**STAFF REPORT: 05/08/2024 REGULAR MEETING**

**APPLICATION NUMBER: HDC2024-00116**

**ADDRESS: 1459 EDISON**

**SCOPE: ERECT GARAGE (WORK COMPLETED WITHOUT APPROVAL), REHABILITATE EXTERIOR OF DWELLING**

*Fig 1, by Applicant: Proposed garage elevations.*

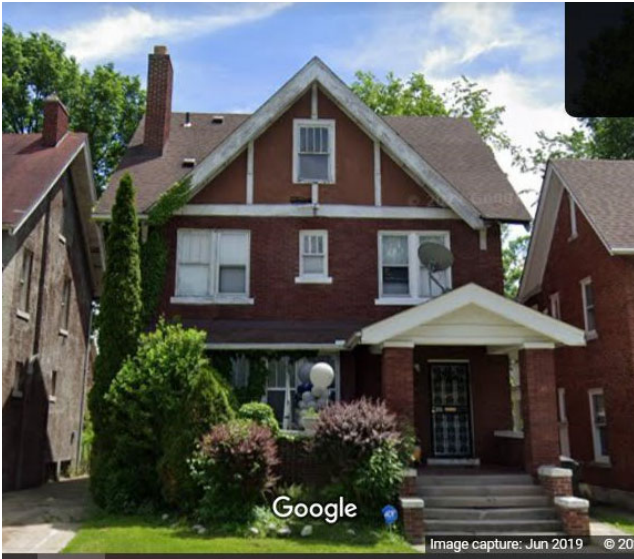
- Although partially completed without approval, staff observed that the overall scale, roof pitch and location of the garage is appropriate for the district and meets the Elements of th Design. However, the use of concrete block as final external material is not appropriate and would be considered incomplete and inconsistent if left unfinished. Staff recommends an appropriate cladding that matches the primary structure to complete the design of this structure or a finish compatible with the district.

- The remaining materials, including the hardie siding, dimensional asphalt shingles and the steel garage door are appropriate new construction in for the district, in staff's opinion. However, staff recommends that the colors of the siding and garage door be selected from the HDC Color Guide to more accurately coordinate with the historic color palette of the house, which is Color System D.

- While the proposed garage, with modest gable pitched roof, Hardie siding at the gable, garage door, and modest scale are an appropriate scale and form that complements the house, the materiality of the concrete block is not appropriate. Staff recommends a brick cladding that matches the house would be an appropriate solution. Staff recommends also recommends that the color white for the siding and the garage door be updated to one that is selected from the HDC Color Guide, Color System D, for English Revival architectural styles.

- The applicant submits a design that shows exterior cladding, such as brick, that is compatible with the property and/or district.
- The applicant provides HDC staff with a garage door and siding color that is selected from HDC Color Guide.
